TECHNICAL SUPPORT BULLETIN

Models Affected: All FP-530 and FP-541 battery operated printers.

Sample of new label:

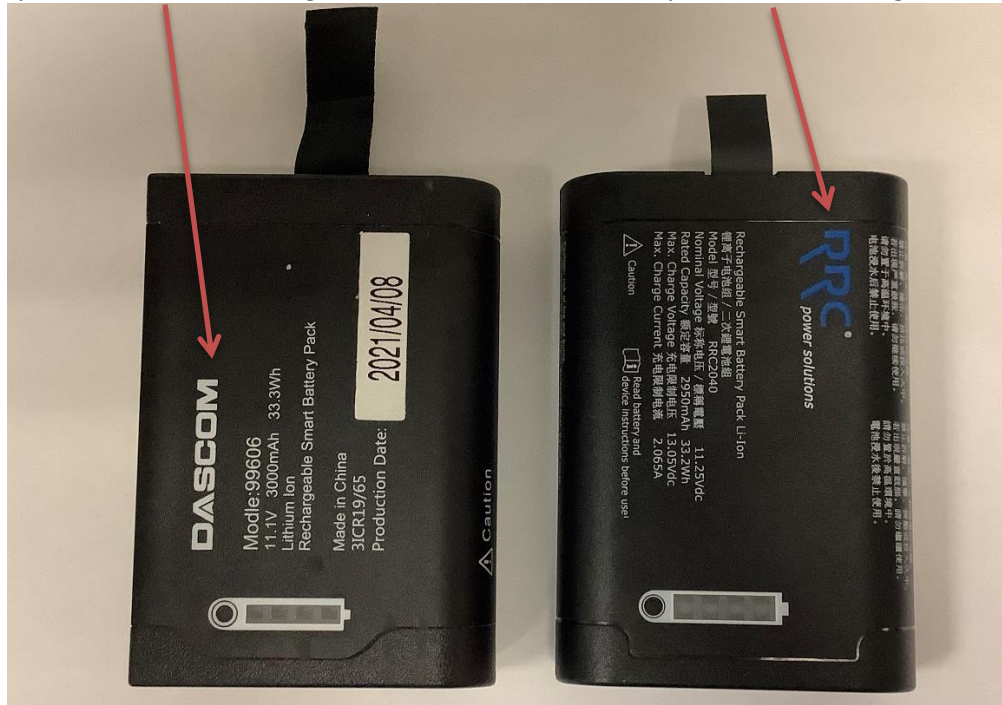
The new printer part numbers will be marked "SE" on the serial and shipping labels.
